## Maryland Park, Lot 110

# DSP-18030

STAFF REPORT

SUBJECT: Detailed Site Plan DSP-18030  
Maryland Park, Lot 110

**Figure 1: Proposed Architectural Elevations**

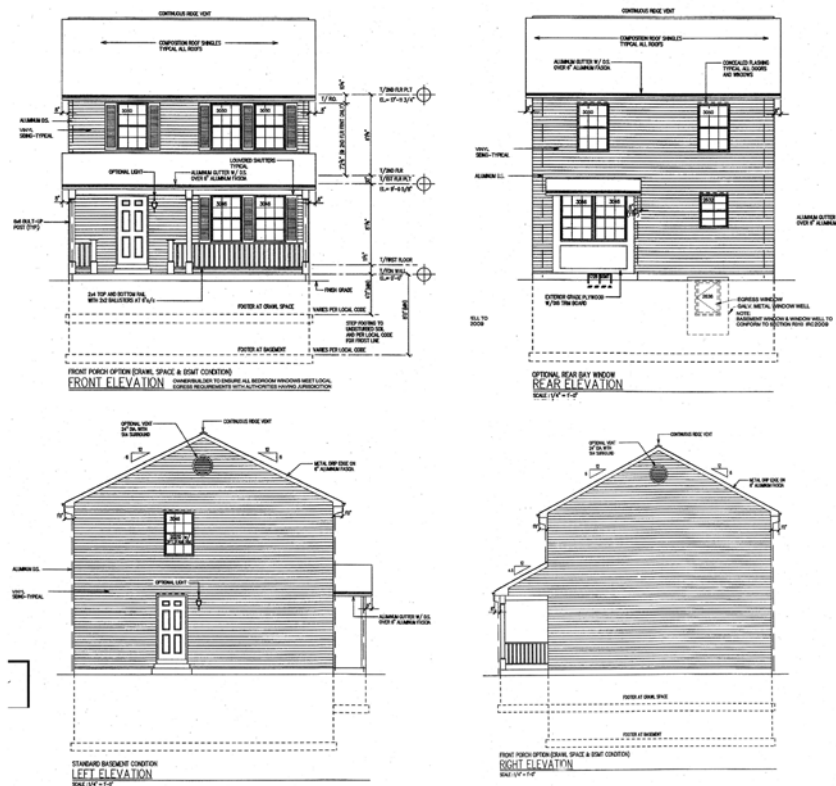
The applicant has proposed a two-story, 2,184-square-foot, single-family dwelling with a gabled roofline that is approximately 28 feet in height. The use of durable, quality materials is proposed on the building and includes vinyl siding, aluminum, and glass, with an entrance proposed on the front building face. The building is accented by a covered porch, which spans 27 feet along the front width of the house. The front elevation is further accented by a combination of five windows and louvered shutters that break up the face of the building. The rear and side elevations are finished with vinyl siding matching the front elevation, and includes an option for a bay window off the dining room on the rear elevation. The left-side elevation includes a second entry and a single window on the second story, while the right elevation does not include any architectural features. Staff recommends a minimum of two architectural features on the right-side elevation, to enhance the appearance of the building. Features such as accent, or standard windows will add visual interest to the elevation while increasing natural light in the house. A condition is included herein requiring this modification.

In addition, it is noted that two front elevations have been submitted, but they do not accurately reflect what is being proposed. These architectural elevations include the Mt. Airy II value plan and the Mt. Airy II enhanced plan. The value plan offers a second entry on the left-side elevation, and a small covered porch on its front. The enhanced plan offers an option with a garage and family room on the left elevation, with a deck on the rear, and covered porch on the building's front. The submitted application proposes a combination of options shown in both the value and enhanced plan, and should clarify which options are being included with this DSP. A condition requiring clarification is included in the Recommendation section of this report.

- d. Provide a minimum of two architectural features on the right-side elevation.
  - e. Provide a photometric plan demonstrating that appropriate lighting levels are being proposed site and that no light spill-over is proposed onto adjacent properties, to be reviewed by the Urban Design Section as the designee of the Prince George's County Planning Board.

- h. Revise the detailed site plan to correctly identify and demonstrate all of the approved alternate transit development district standards.
  - i. Revise the architectural elevations to clearly identify the building options and finishes proposed with this detailed site plan and reflect these improvements on a revised housing template.

**Figure 2: Proposed Building Setback**

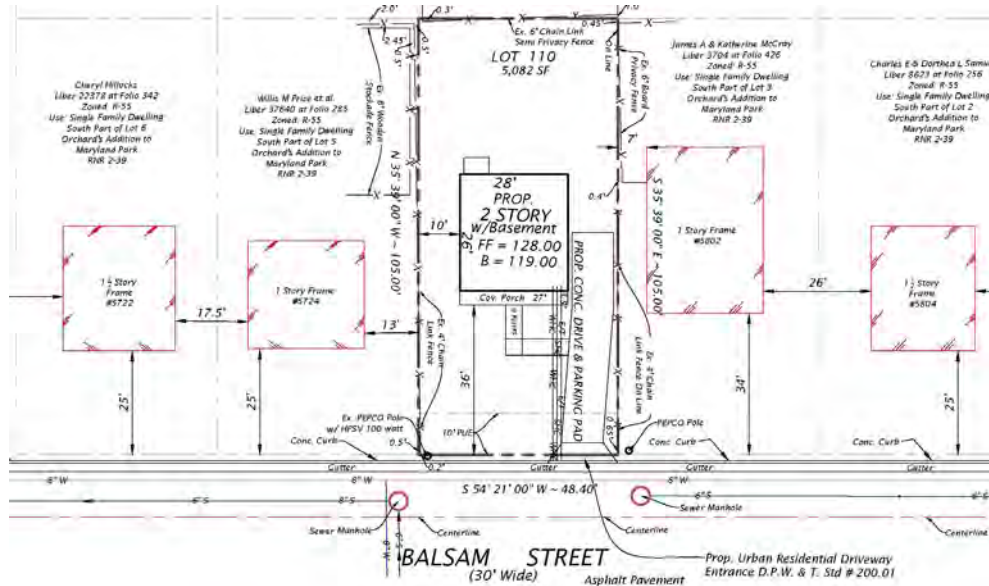
The building setback from the curb is not delineated on the plan; however, it is shown at approximately 36 feet from the right-of-way of Balsam Street to the covered front porch. The proposed building does not meet this standard and an amendment is necessary. Staff recommends that the amendment be approved, as the proposed building location is generally consistent with the adjacent properties and will not substantially impair the implementation of the Capitol Heights TDDP.

- A. APPROVE the alternative transit district development standards for:
  - 1. Urban Neighborhood—Single-Family Detached Character Area, Build-to-Line: To allow the building setback from the face of curb to be increased from 10–15 feet to a maximum of 37 feet.
